Stonybrook Creek Culvert Replacement Bridge Design Report

Niles Canyon Safety Improvements Project (04-2A332)

Appendix C CDFW 2005 Stonybrook Creek Memo

Subject: State Highway 84 project at Palomares Road, Stonybrook Creek, Alameda County

Photo 1. Photo and Comments of the Boulder Grade Control Feature from CDFW Memorandum (2005)

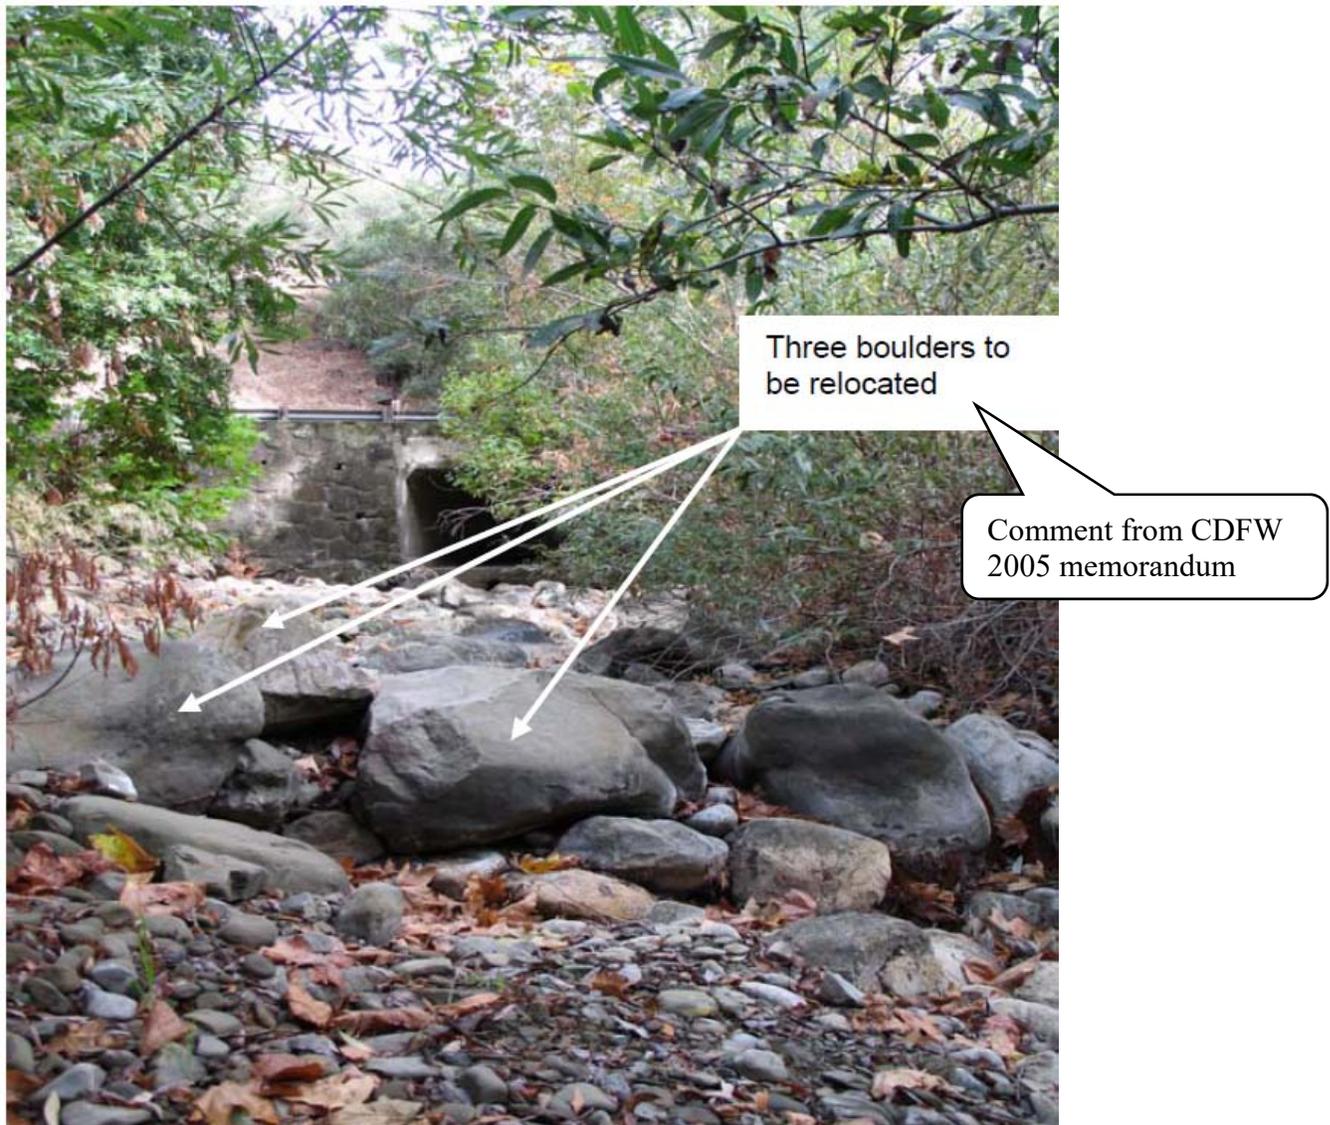
4. **Redesign or redistribute the boulders forming the boulder grade control feature downstream of the culvert outlet** (see Attachment). It seems likely that sometime in the past a high flow event evacuated sediment that had accumulated in the channel at this location, and that the grade control was built to prevent the channel degradation from migrating upstream to the culvert outlet and further deepening the scour hole and undermining the crossing. The channel downstream of the grade control is steeper, but appears to be quite stable. As noted above, this grade control structure is trapping sediment to the detriment of upstream channel form, habitat diversity and fish passage. Redistributing the boulders will allow the substrate elevation to naturally fluctuate with changes in flow and sediment supply. Alternatively, if the change in grade is too great to even out over the project reach, and it becomes necessary to keep some form of grade control at this location, then the structure should be redesigned to include a low flow channel notch consistent with the location and shape of the low flow channel immediately downstream.

CDFW described the BGCF as being constructed of boulders, and provided a photograph showing the existing boulders sitting on top of the bed of the creek (see Photo 1) with cobbles on the bed of the creek downstream. CDFW reported the BGCF is, “trapping sediment to the detriment of upstream channel form, habitat diversity, and fish passage” and that downstream of the BGCF, “is a well-defined and fish passable boulder cascade.” CDFW previously recommended the boulders to be relocated, as shown in the comment added to the photograph reproduced below.

Observations made by WRECO in 2019 found that the boulders of the BGCF were more embedded and interlocked than they appear in the photo from 2005, and that the streambed downstream of the feature was lower in elevation where a plunge pool had formed (see Photo 2). The plunge pool did not contain the cobbles shown in the photo from 2005 (see Photo 3).

In summary, Stonybrook Creek appears to have adjusted to the presence of the BGCF since the CDFW observations made in 2005. The BGCF appears to have decreased sediment transport, and low flows in Stonybrook Creek are divided with a smaller portion flowing over the BGCF and a larger portion following a longer flow path to Alameda Creek. Neither low-flow path appeared to be ideal for fish passage. In the 2005 memorandum, CDFW recommended alteration of the BGCF,
